Permit Number: C-1981-035

Mine Name: King Coal Mine Operator: GCC Energy, LLC Operator Address: Mr. Tom Bird	Operation Type: Underground Permit Status: Active Ownership: Federal	
6473 County Road 120	<b>Operator Representative Present:</b>	
Hesperus, CO 81326	None	
Operator Representative Signatu	re: (Field Issuance Only)	
INSPECTION INFORMATION		
Inspection Start Date: November Inspection Start Time: 15:00 Inspection End Date: Inspection End Time:	Inspection Type: Aerial Inspection Inspection Reason: Normal I&E Progra Weather: Clear	m
Joint Inspection Agency:	Joint Inspection Contacts:	
None		
Post Inspection Agency:	Post Inspection Contacts:	
None		
Inspector(s):	Inspector's Signature: Signature	e Date:
Harry B. Ranney	Phot D 71

The King Coal Mine was photographed from an airplane by Harry Ranney of DRMS on November 27, 2017. The weather was clear. The photos were reviewed by Rob Zuber of DRMS on November 28, 2017, resulting in the following report.

King I – lower area with improvements of ponds

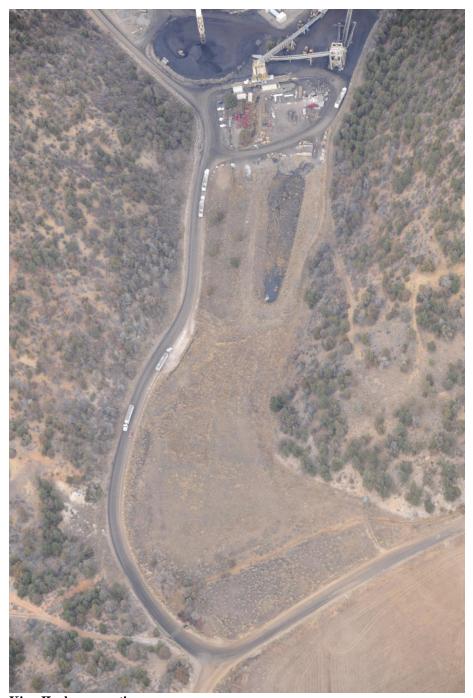
At the King I Mine, the West Pond and East Pond were dry. The pasture below the pond spillways showed no sign of discharges from the ponds in recent weeks. The photographs show that work has been done on both King I ponds, and GCC has confirmed that primary spillways were replaced at both ponds (per Tom Bird email). Also, material has been added to the embankment of the East Pond. All of this work has been performed to make the ponds meet the specifications in the PAP designs.
